VTech Telecommunications Ltd

Purpose of Change

Re: Application for a Permissive Change Filing with

The purpose of this document is to describe all the changes that are made on new model **DLP73540** from the original model **DLP73540** in order to meet the requirements.

Changes of BS from the original model to the new model:

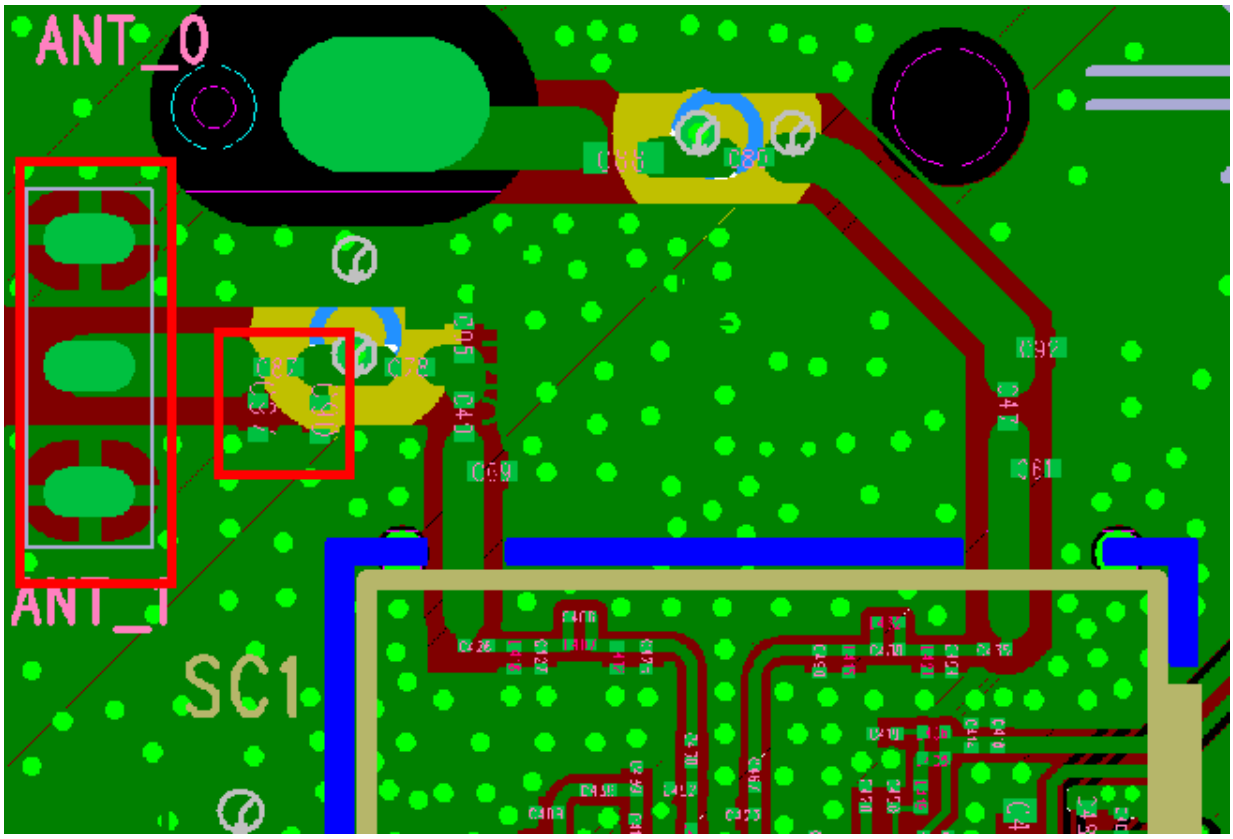
- Change the BS layout for the RF antenna match circuits
- Change the BS antenna match circuits
- Change BS ANT1 from shaft antenna to three wires antenna for new model
- Ten pao adaptor was removed, and Ao Hai adaptor was added (100-240VAC 50-60Hz 0.15A to 5.9VDC 0.6A)
- Flash changed from 464A-2GLI to BL24C64B

Original flat cable soldering pad	New flat cable soldering pad

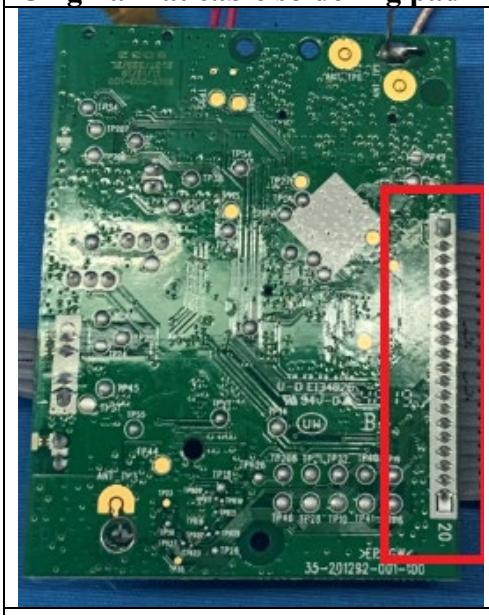
- New flat cable soldering pad, each pins to added with 100pF capacitance to ground to improve EMC.
